CHAPTER 2: MODIFICATIONS TO THE 2005 DEPARTMENT OF ECOLOGY STORMWATER MANAGEMENT MANUAL FOR WESTERN WASHINGTON

2.1 Redmond Requirements

2.2 Key Modifications for Redmond

Figure 2.3R Flow Chart for Determining Requirements for Redevelopment in Redmond.

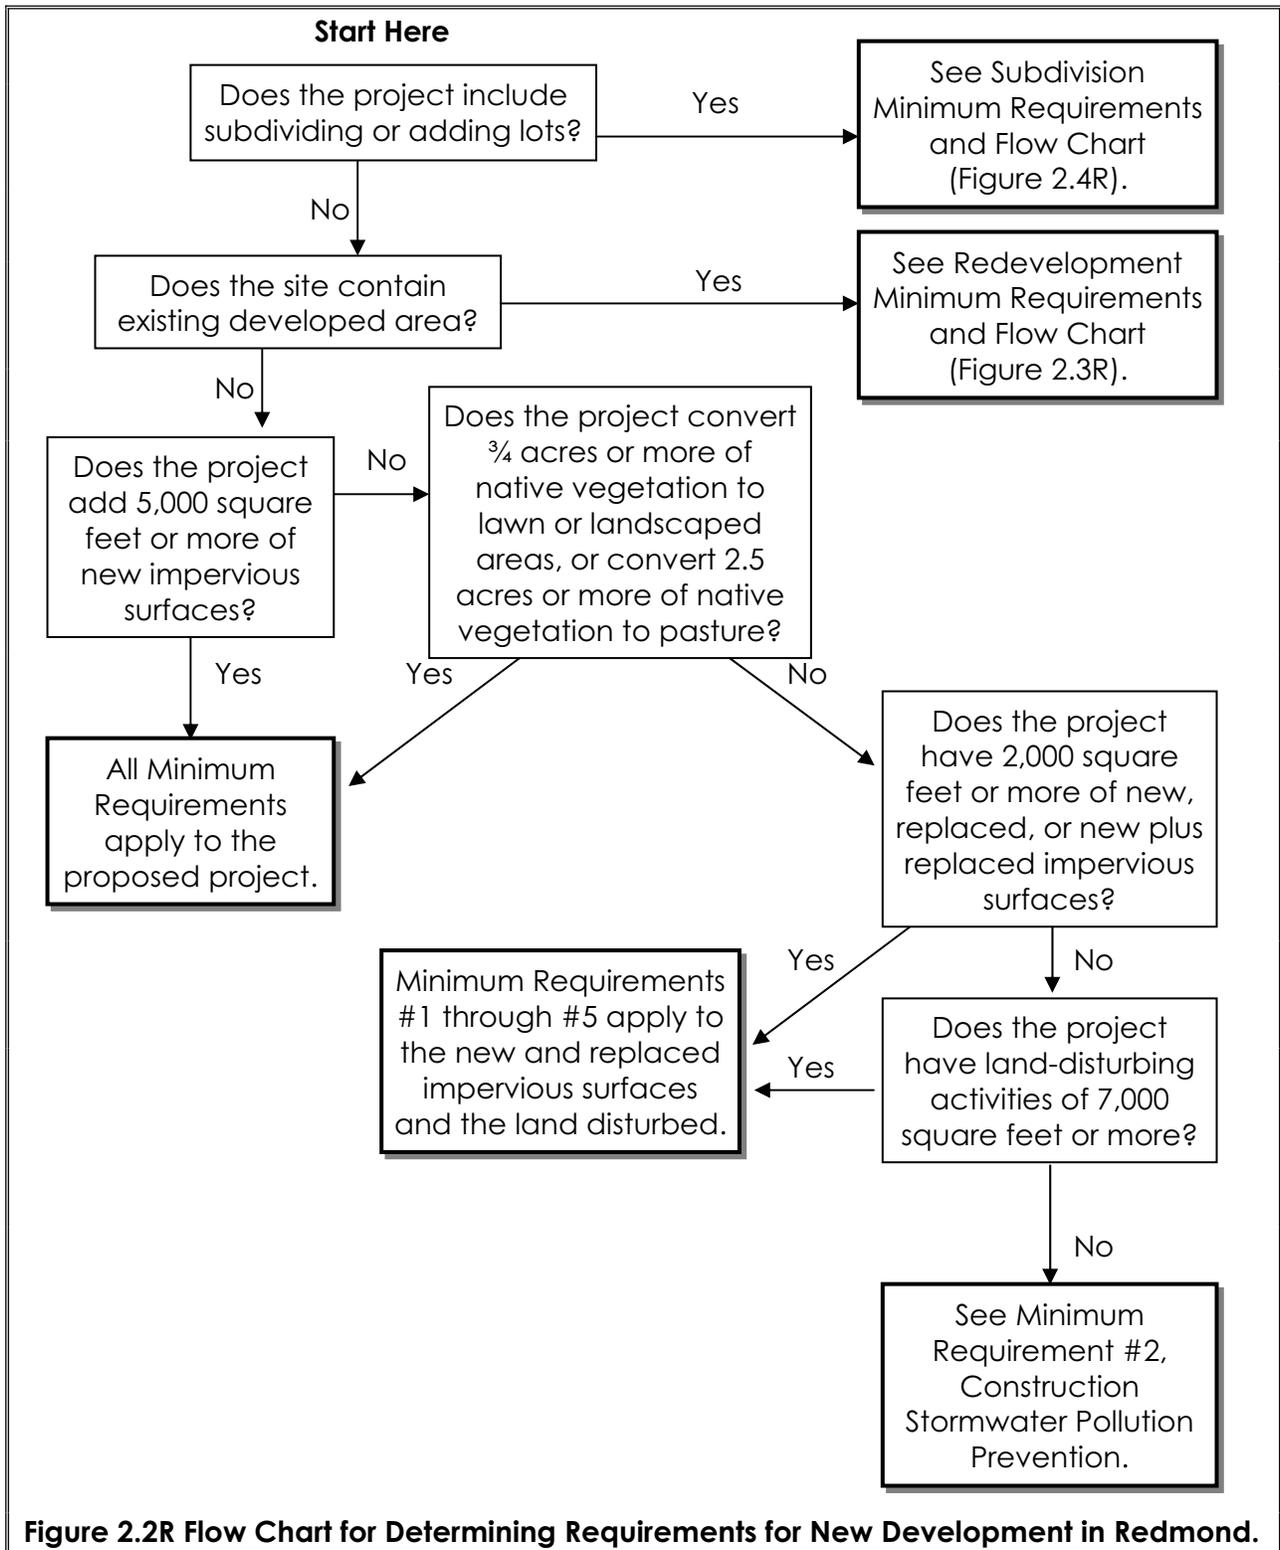
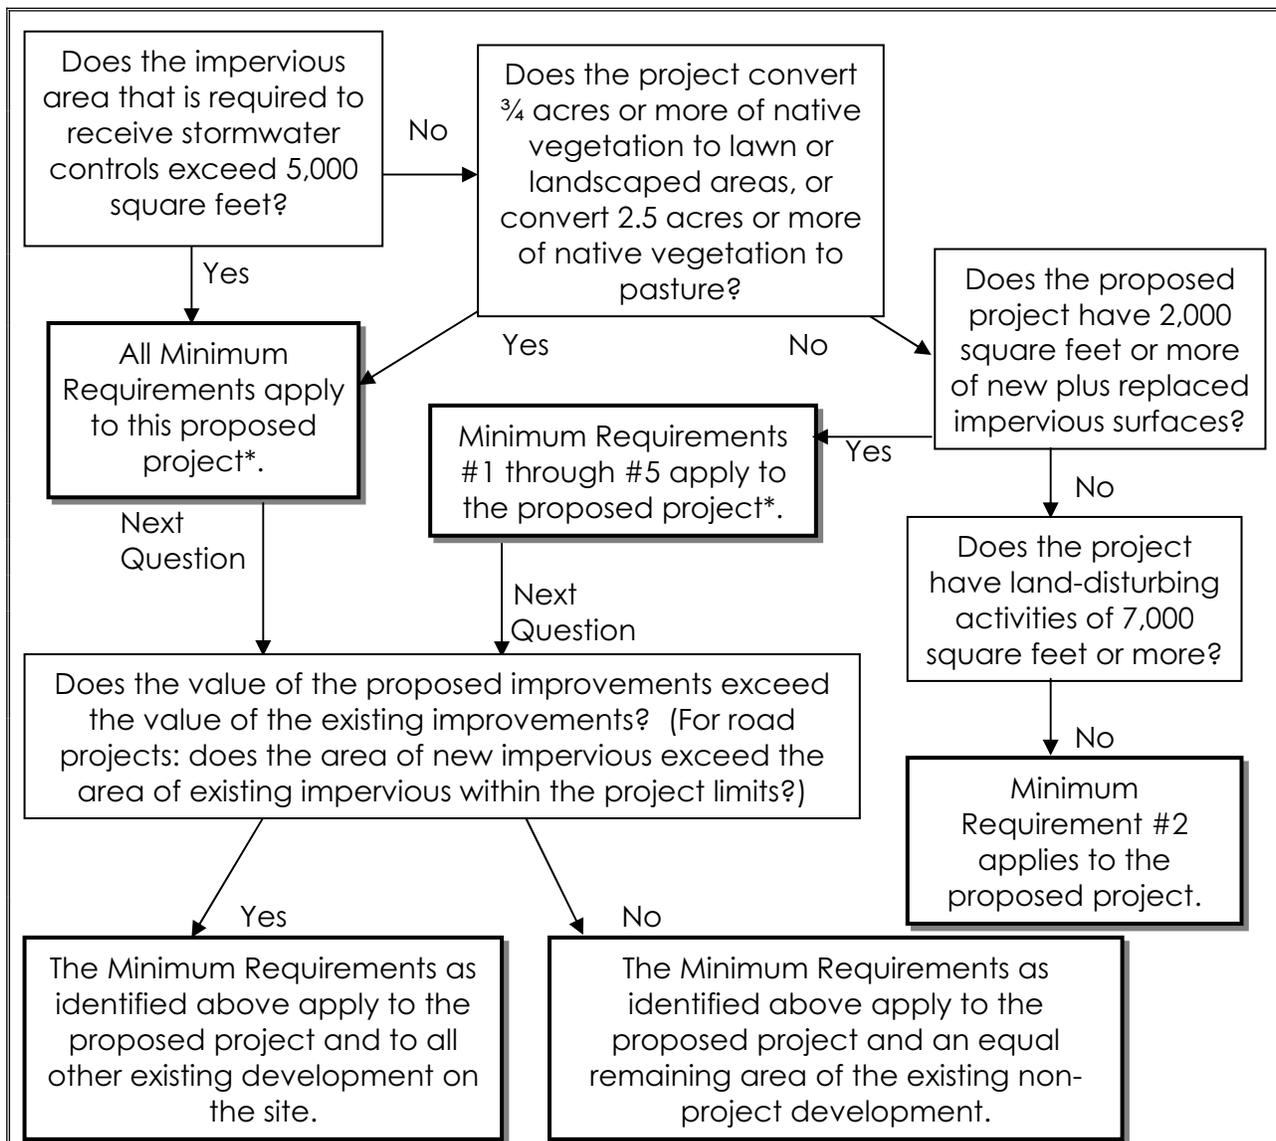
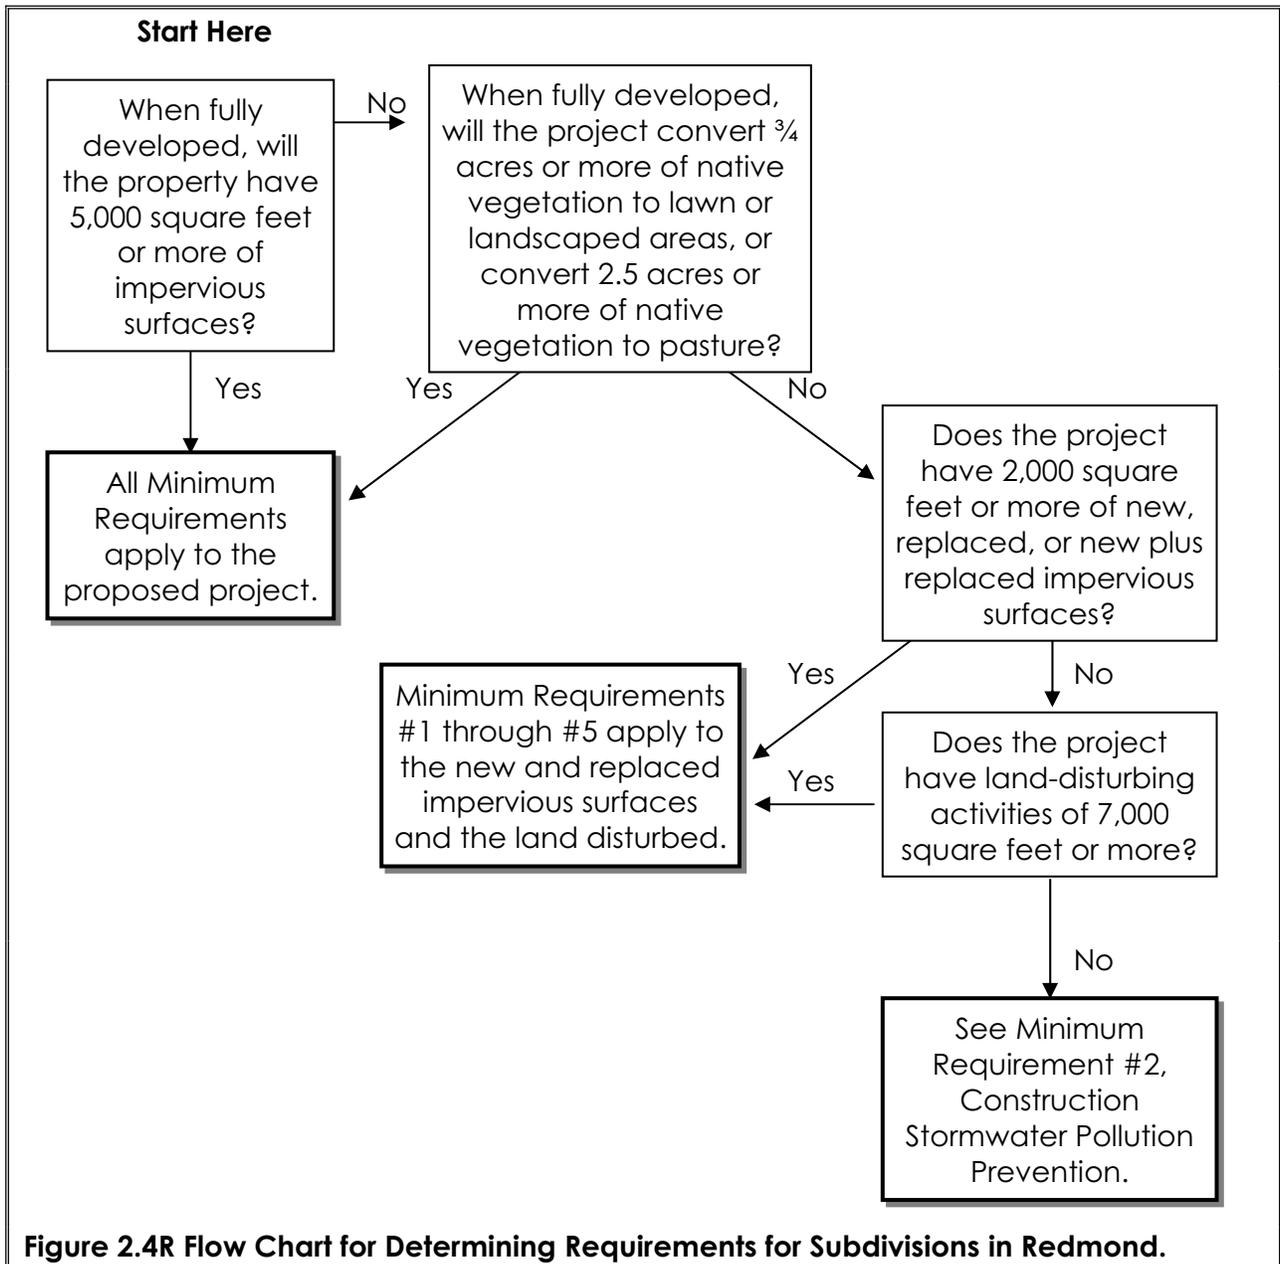
Redmond treats re-development differently than the 2005 Ecology Manual. The differences are explained below and require that Figures 2.2 and 2.3 in the 2005 Ecology Manual be revised for Redmond. The revised Redmond figures (labeled 2.2R, 2.3R, and 2.4R) follow.

Do not apply in Redmond. See 2.2R, 2.3R, and 2.4R below.

* In determining project area, include areas of the site with:

- Proposed new impervious surfaces, and
- Existing impervious surfaces that will be disturbed as part of the project, and
- All other areas that will be disturbed by the proposed project, and
- Additional existing development as required per "New Development" or "Re-development" definitions.

A landscaped area is disturbed if the earth surface is penetrated or roots are disturbed. A paved area is disturbed if the surface below the base course is disturbed.

Figure 3.1R Diagram for Selection of Roof Downspout Controls in Redmond (Single Family Homes Only)

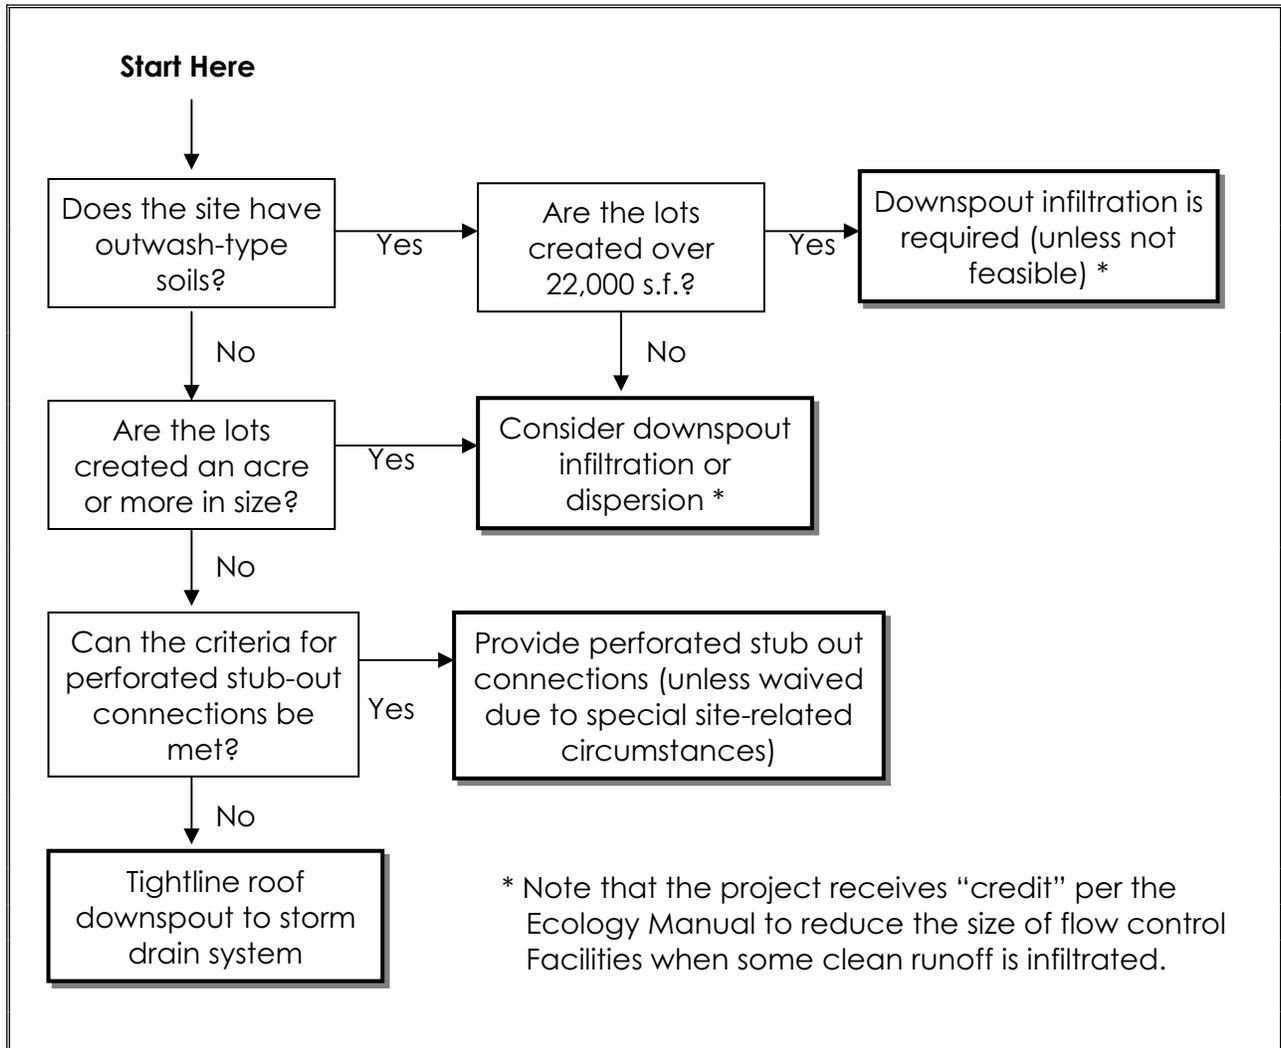
Figure 3.1-Flow Diagram Showing Selection of Roof Downspout Controls

Does not apply. Use Figure 3.1R, below, instead.
